PLANNING

Project **7 Warwick Court**

Drawing Title: **Demolition & Proposed Rear Elevation**

Drawing No. **P_09** Rev. **D**

Proposed Rear Elevation

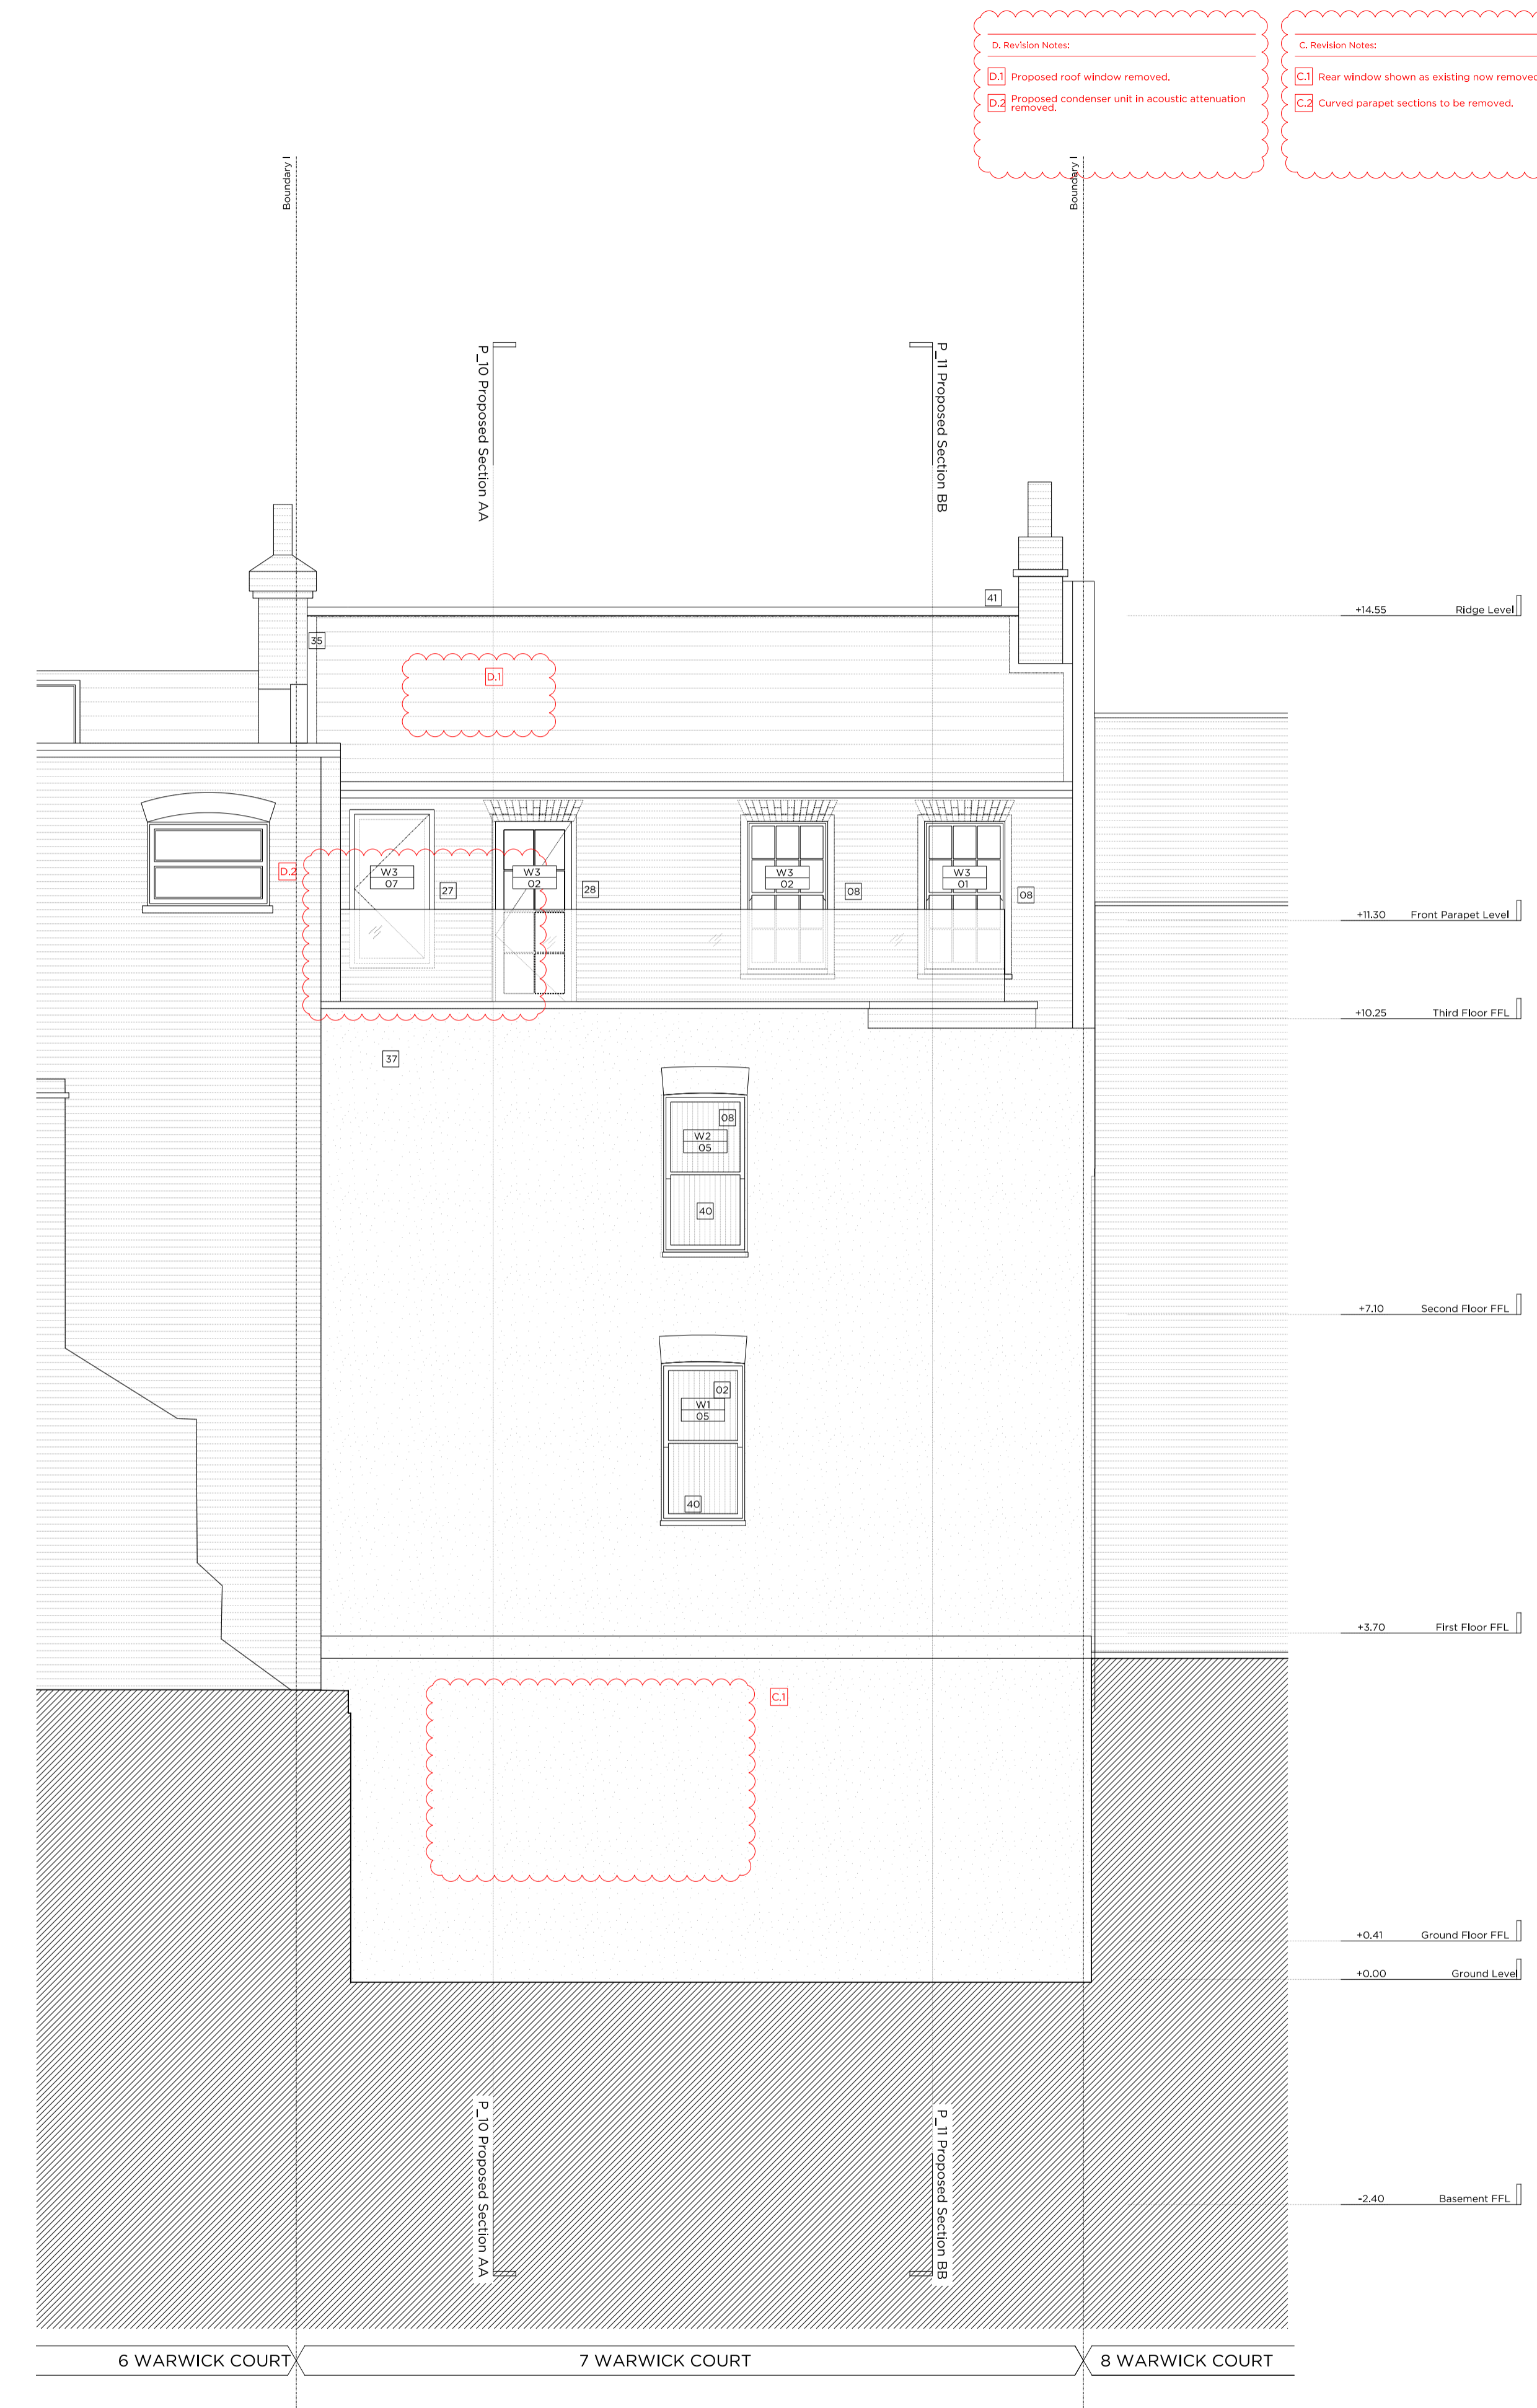
- B. Revision Notes:**
- 01 Proposed roof window removed.
 - 02 Proposed condenser unit in acoustic attenuation removed.
- C. Revision Notes:**
- 03 Rear window shown as existing now removed.
 - 04 Curved parapet sections to be removed.
